## Technical Bulletin

### Potential for High Voltage on W Terminal

Document #: TB-FLEX-01292024

Product Group: FLEXX

Part Number: 300002062550

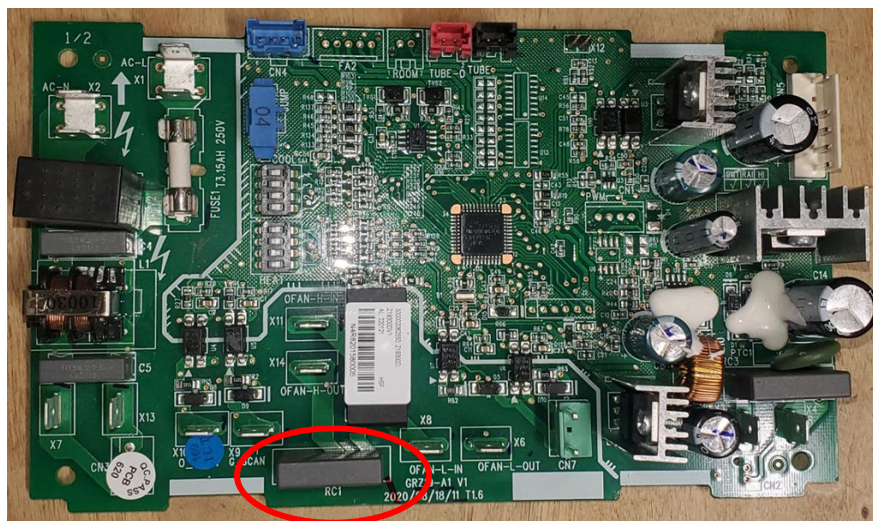
**Note: If there are no wires on X11 & X14, there is no capacitor at RC1, or the date code falls outside of the production date, please disregard this bulletin.**

FLEXX BH model replacement main board 30002062550 has a capacitor labeled RC1 that connects high voltage into the low voltage W circuit. If the thermostat makes a call for heat on W, high voltage will travel into the thermostat on W causing damage.

The issue has been addressed at the factory. Boards produced since April 15, 2022 do not have the capacitor at RC1.
